**Re: Design of Roads and Streets manual**

Thank you for the opportunity to provide feedback on the draft Design of Roads and Streets manual (DORAS).

Cycle infrastructure and lane reallocation is **not shown** as a design solution for "transit arterials"

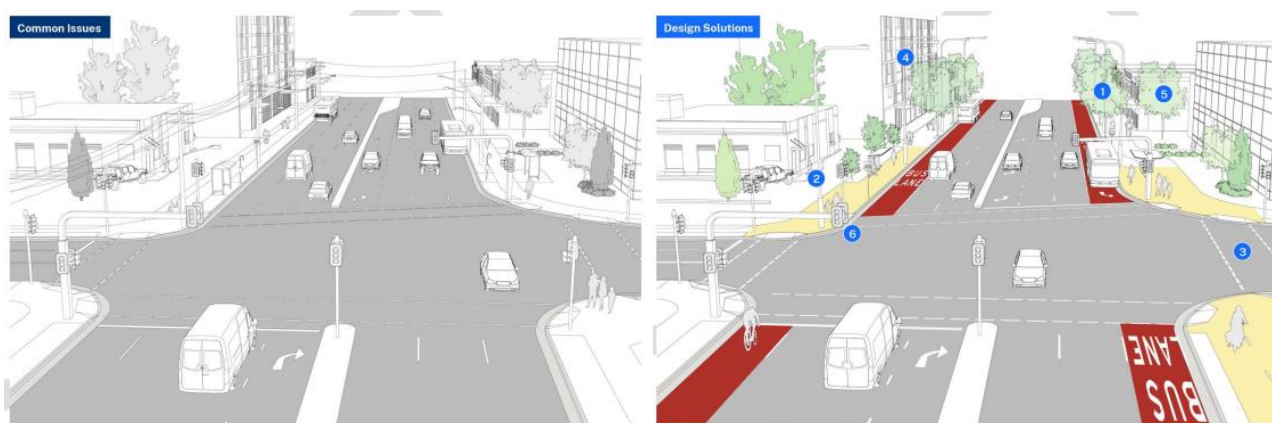
As already highlighted, the guide is long, and Bicycle NSW has not studied each typology and the associated design solutions in detail. However, the discussion of issues and possibilities for "transit arterials" (Section 8.3.2) stands out as an example of the missed opportunities in DORAS.

This is despite the excellent multi-modal street diagram from Transport for NSW's own Future Transport Strategy, which is front and centre in the DORAS introduction:

Transit arterials include roads such as Military Road, Broadway and Victoria Road. These roads constantly feature in our advocacy for road space reallocation. They are where many of the Strategic Cycleway Corridors are slated to go.

A much more ambitious vision is needed for arterial roads. DORAS should direct practitioners to apply the Road User Space Allocation to reimagine traffic sewers as multi-modal corridors. Include options for a complete overhaul of 'transit arterials' that focus on less car traffic, more landscaping and public space, lower speeds and multiple transport options for everyone in the community.
